JASIC opinion towards formation of TF-BTA

Informal document
GRSP-55-41

Figure 5C: Determination of Corner of Bumper with corner gauge

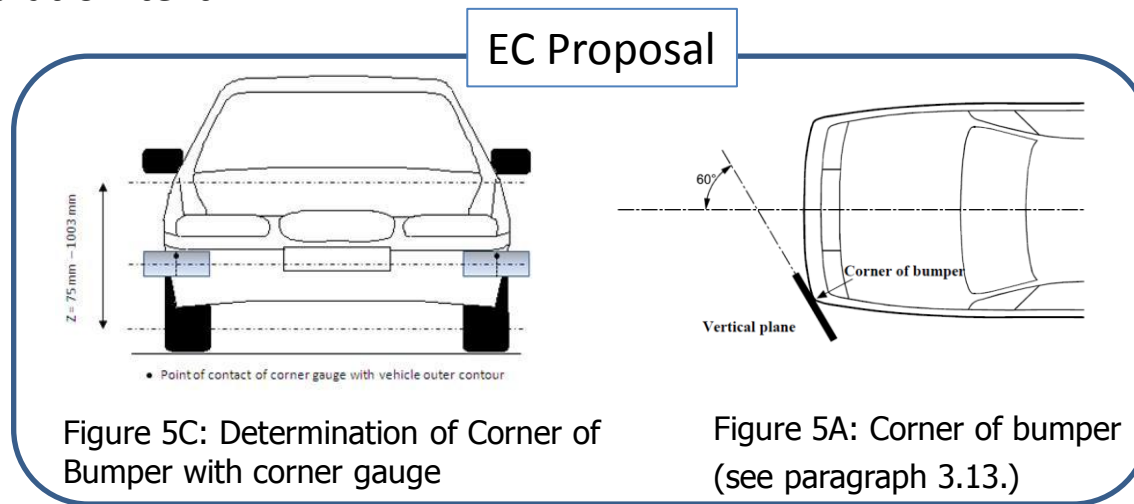
- The EC proposal (see below figure) does not require technical validation because of the use of 60 degrees threshold. Therefore, once EC proposal is accepted, the only thing to do is to discuss technical feasibility of the proposal to develop details of the proposed regulation text.
